**P94-027 - 5TH STREET WAREHOUSES**

**REQUEST:** A. Tentative Map to subdivide 6.75± developed acres into three parcels in the Light Industrial (M-1) zone.

**LOCATION:** East side of 5th Street - North of Merkley Way  
009-0030-047  
Land Park  
Sacramento Unified School District  
Council District 4

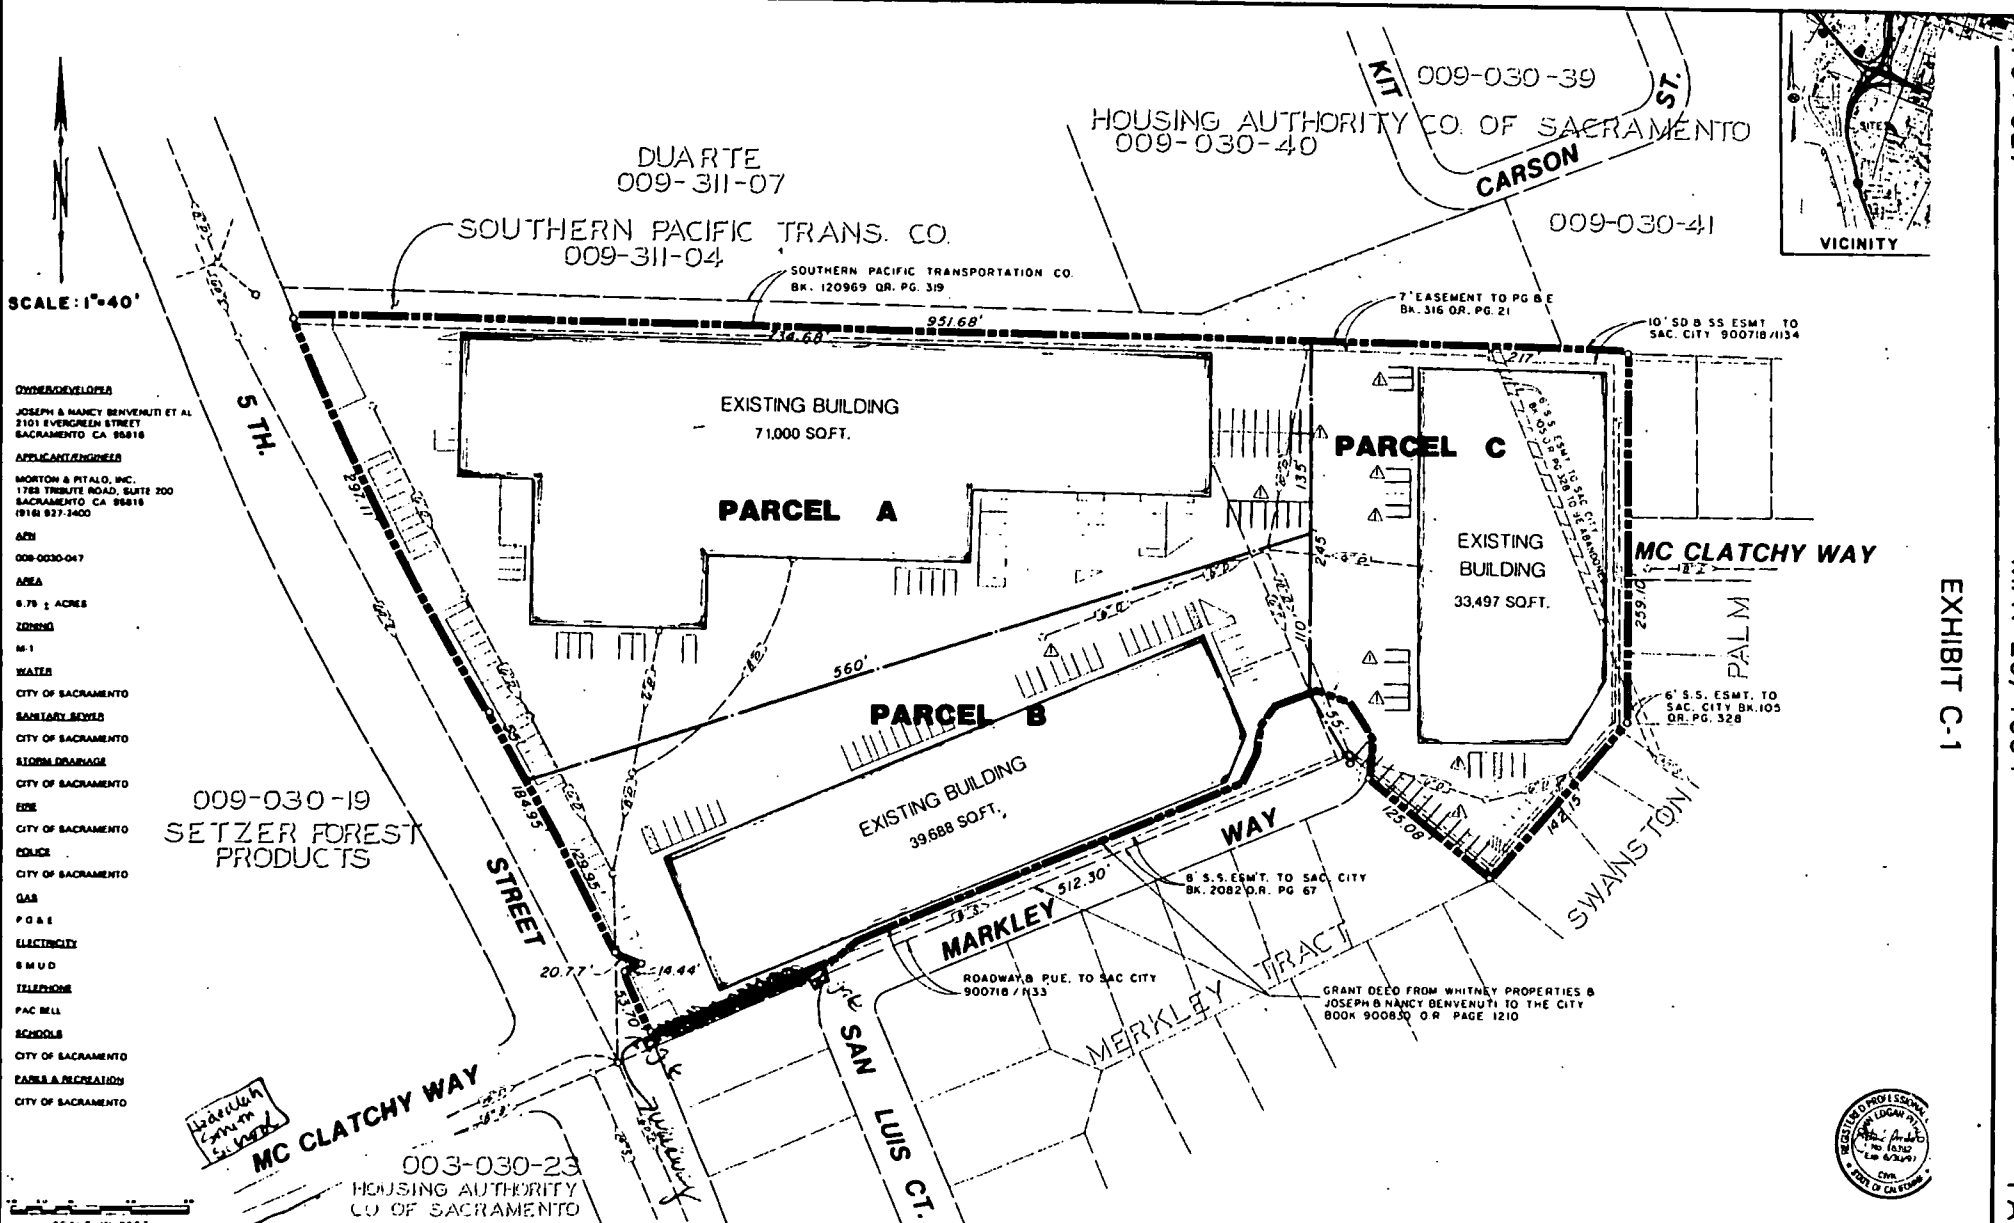
The existing warehouse building on Parcel C extends over a property line. The portion of the structure that extends over the property line must be removed and has been made a condition of this project.

There is a pedestrian walkway that connects San Luis Ct. with 5th Street (See Exhibit C-1). A school is located off of McClatchy Way and the schoolchildren have used this walkway in the past in order to get to school. The pedestrian walkway is currently gated and locked because the school cannot afford a crossing guard at this time. The gates will remain locked until the school can afford to hire a crossing guard.

- E. Obtain and comply with abandonment clearance letters for the abandonment of sanitary sewer under Parcel C on the Tentative Map. Letters shall be provided to the Public Works Department. Abandonment may be recorded with the Final Map or by separate abandonment hearing.

- H. Provide street lighting along Merkley Way (system that was installed at time of building permit has not been completed).
- I. Remove existing accessory structure which crosses Parcel C and the Southern Pacific Rail Road property line.

- J. Conform to the City's Cross Connection Control Policy to the satisfaction of the Utilities Department.
- K. The existing pedestrian walkway is to remain gated and locked until it can be staffed by a school crossing guard. At that time the walkway can only be opened during school hours and only when the crossing guard is present.

- E. Obtain and comply with abandonment clearance letters for the abandonment of sanitary sewer under Parcel C on the Tentative Map.

Letters shall be provided to the Public Works Department. Abandonment may be recorded with the Final Map or by separate abandonment hearing.

- J. The existing pedestrian walkway is to remain gated and locked until it can be staffed by a school crossing guard. At that time the walkway can only be opened during school hours and only when the crossing guard is present.

- K. *The pedestrian walkway shall have the days and hours of operations posted. (added by staff 6/16/94)*
- L. *The wall and gate of the pedestrian walkway shall be raised to a minimum height of 9 feet (a building permit may be required). (added by staff 6/16/94)*

- M. *The concertina wire on the top of pedestrian walkway shall be removed. (added by staff 6/16/94)*
- N. *The applicant shall replace the existing chain link fence with a solid 6 feet minimum height fence with a minimum 20 ft. gate in the cul-de-sac of Merkle Way. The fence design and materials used shall be subject to the approval of the Planning Director and the Fire Marshall. (added by staff 6/16/94)*

- O. *The applicant shall maintain on a regular basis trees and foliage along the south of Parcel B along side of Merkle Way. (added by staff 6/16/94)*

- P. *The applicant shall pave the pedestrian walkway with concrete or asphalt. (added by CPC 6/23/94)*
